Bay Fair Transit Oriented Development (TOD) Specific Plan

Final Environmental Impact Report

Final Environmental Impact Report

Alameda County Watercourse Protection Ordinance Section 13.12.320: Setback Criteria

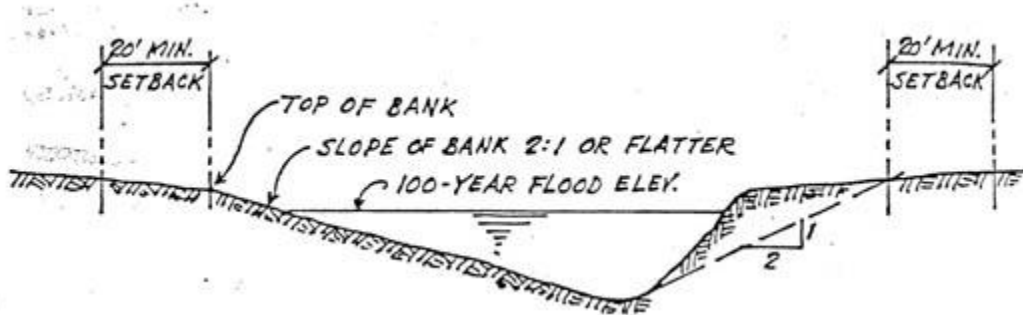
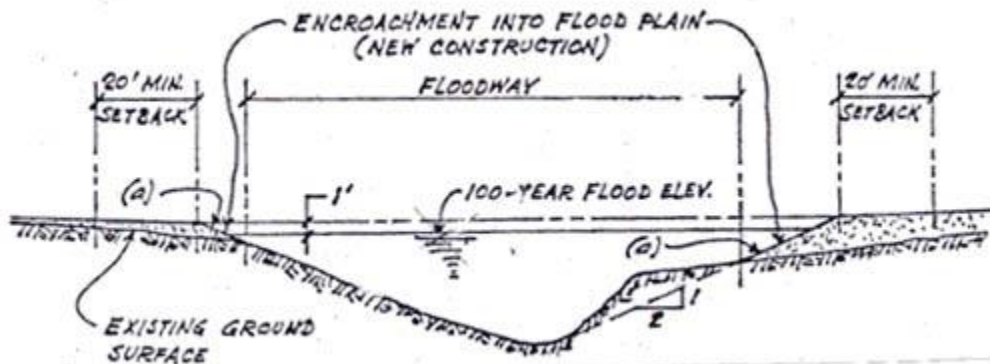
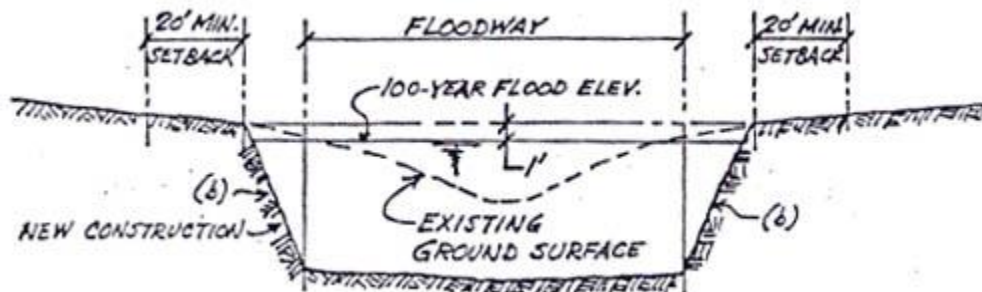
In addition to such statements, the DEIR and/or draft TOD plan should include statements, guidelines, or requirements for setback distances for new-development from the creek channel to allow for potential re-configuring or naturalizing the creek channel, riparian area, and/or public access.

These comments pertain to the provisions and requirements set forth in the Draft Specific Plan itself and do not pertain to the findings or conclusions of the Draft EIR. Chapter 2, Vision and Planning, of the proposed Specific Plan envisions the Estudillo Canal as an “attractive, ecologically valuable open space amenity over time.” In addition, Public Open Space Guideline 5 in Chapter 5, Development Standards and Guidelines, calls for “new open space located along the Estudillo Canal” that “should function as a stormwater management feature.” As described in Section 4.8, *Hydrology and Water Quality*, of the Draft EIR, the San Leandro Municipal Code Chapter 3-15 *Stormwater Management and Discharge Control* provides stormwater requirements for projects conducted within the City of San Leandro. Included in Chapter 3-15 is the San Leandro Watercourse Protection Ordinance, which requires each property owner to keep and maintain parts of a watercourse that flows through their property free of trash, debris, excessive vegetation, and other obstacles. Also, no development within 30 feet of the centerline of any creek or 20 feet from the top of the bank is allowed without written authorization from the City.
